Eliminating Horizontal Pull

PRODUCTION CHANGES

Figure P-1. Change No. 41, RA-109A.

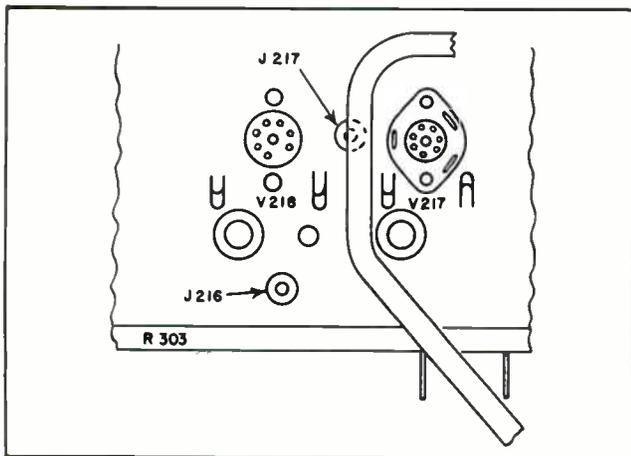
To reduce horizontal pulling, two jacks are provided as described in the article entitled "Eliminating Horizontal Pull," in this issue.

Mount the two jacks, J216 and J217 as shown in figure P1.

Figure P-2. Change No. 39, RA-112A - RA-113.

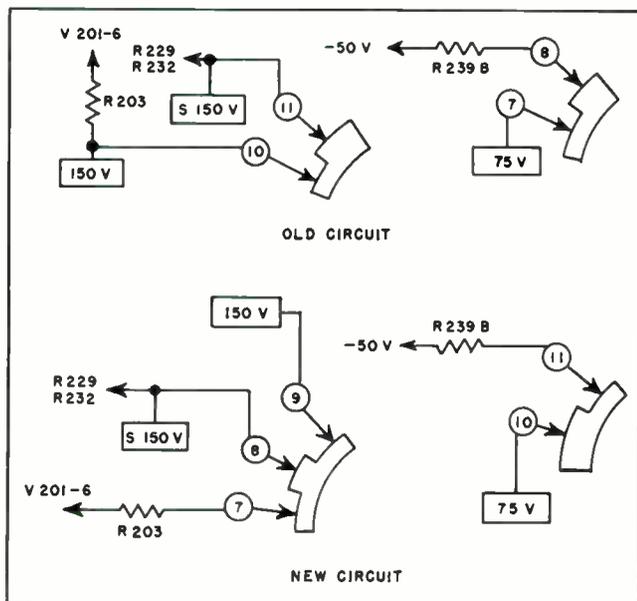
To eliminate f-m pickup when the Teleset is being used for phonograph reproduction. This pickup occurs in areas where very strong f-m signals are present and is coupled to the first sound amplifier through the stray capacitance of S201. A position is added to this switch to remove the B+ from the screen of the first sound i.f., V201.

Replace and rewire S201 as shown in figure P2. Connections not shown remain the same.

Figure P-3. Change No. 40, RA-112A - RA-113.

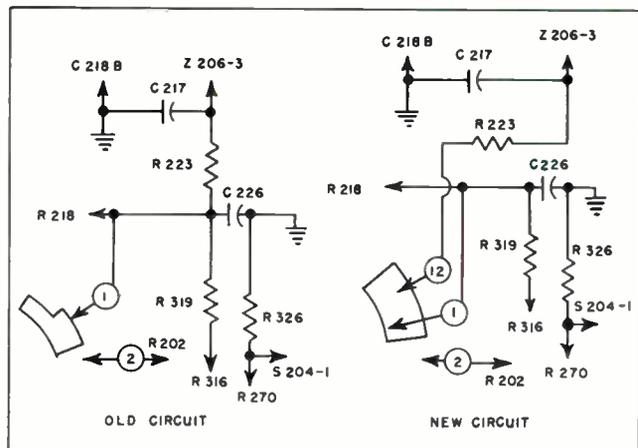
To obtain maximum sensitivity when receiving f-m stations in areas where both extremely strong and weak signals are received. If both strong and weak f-m signals are present at the antenna terminals of the Teleset, it is possible for a strong signal to reduce the gain of the receiver when it is tuned to a weak signal. When this occurs, the reduction in gain may be sufficient to make satisfactory reception of the weak signal impossible.

The above condition can occur if a strong signal is close enough in frequency, to a weak signal so that both signals fall within the pass band of the r-f and video i-f stages, when the receiver is tuned to the weak signal. The strong signal will pass through these stages to the grid of the third video i.f., V207. If the amplitude of the strong signal is great enough, the grid of V207 will be driven positive causing it to draw current. This current will flow through resistors R223, R319 and R251. The voltage developed, by this current, across R319 and R251, appears on the a-g-c line and is applied to the grids of the r-f amplifier (V101), and the 1st and 2nd sound i-f amplifiers (V201 and V202). Since this voltage is negative, it increases the bias on these stages and reduces the gain of the receiver. To eliminate this effect, the grid circuit of the third video i-f stage is disconnected from the a-g-c line when the Selector Switch is in the FM position. To accomplish this, a new Selector Switch is required.

1. Change S201
2. Disconnect R223 from junction of C226 and R319 and connect this end to S201-12, as shown in figure P3.
